APPEAL SUMMARY

Appeal ID: 22165

Project Address: 620 NE 61st Pl

Appeal Type: Plumbing

1 MAXI-FILTRA INSTALLATION DETAIL

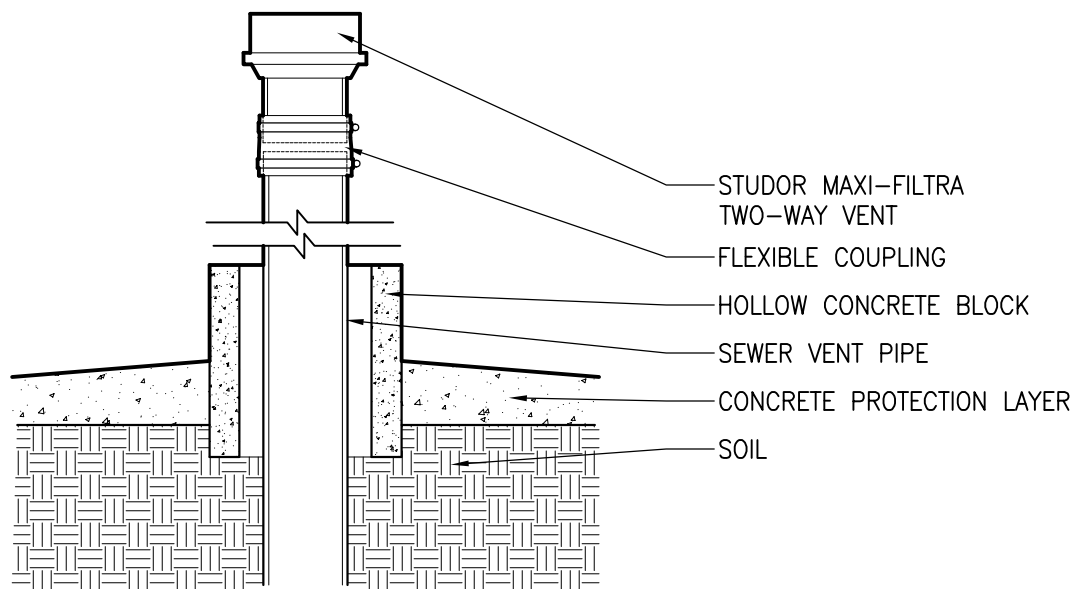
Concern: The Maxi-Filtra can be easily removed.

Response: The push fitting connection is proposed to be replaced with a flexible coupling (which is a Studor-approved installation method), which will render removal more difficult. In addition, we propose installing a hollow concrete block set in concrete over the pipe where it passes through the ground so that it cannot easily be cut off. A proposed installation diagram is attached.

Use of air admittance valve in lieu of roof vent: Granted provided valve is separate from the building cleanout.
